## WEST SUSSEX COUNTY COUNCIL CONSULTATION

<b>TO:</b>	Mid Sussex District Council FAO: Steven King
<b>FROM:</b>	WSCC – Highway Authority
<b>DATE:</b>	15 October 2025
<b>LOCATION:</b>	Land East Of Lunce's Hill Fox Hill Haywards Heath West Sussex
<b>SUBJECT:</b>	DM/25/0827 Outline planning application for the erection of up to 130 dwellings, together with the change of use of an existing barn for a flexible community and/or commercial use, along with associated outdoor space and landscaping, drainage infrastructure, hard and soft landscaping, parking, access and associated works (all matters reserved except for access).  Additional information and amended plans received 03/09/2025.
<b>DATE OF SITE VISIT:</b>	24 April 2025
<b>RECOMMENDATION:</b>	More Information Required

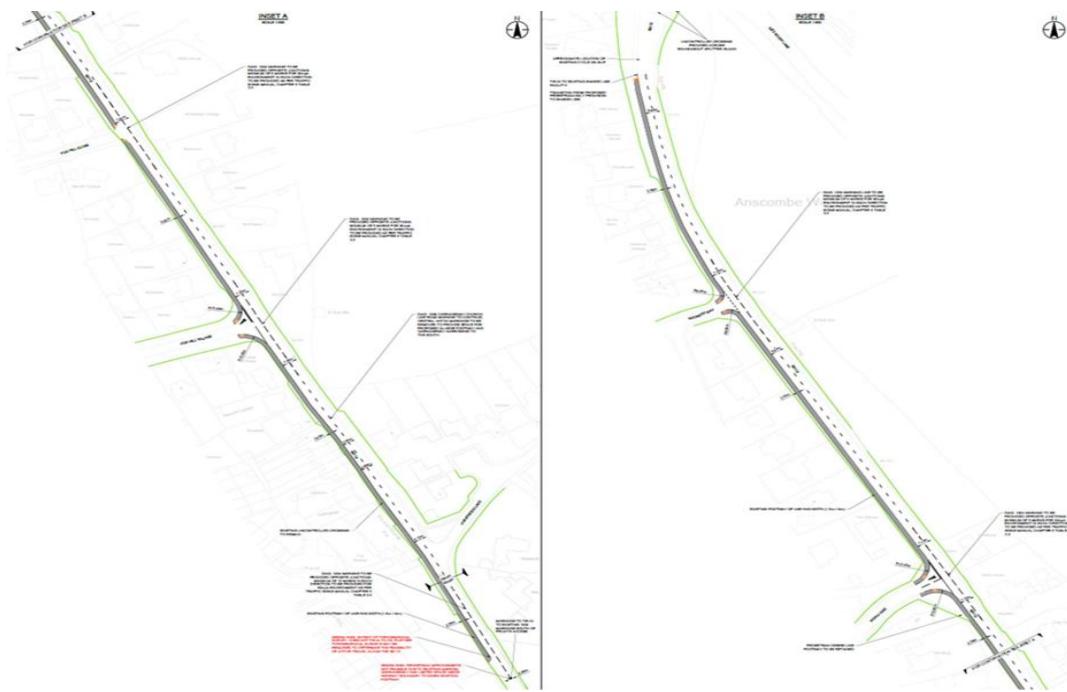
Whilst it is acknowledged that there is limited opportunity to enhance the provision for cyclists along the B2112, there is an opportunity for the existing pedestrian provision to be improved.

Stantec has undertaken a review of the existing provision along the B2112, focussing on the western verge where there is a greater opportunity for improvement. The review is focussed on widening the existing provision to a consistent width, as well as providing tactile paving at the crossings.

The extent of the proposed improvements are shown in the plan below, with the full plan provided in Appendix D.

The above is noted. **However, applicant to confirm whether these improvements are to be implemented as part of this planning application. If they are, then they should also be included in any Stage 1 Safety Audit Brief.**
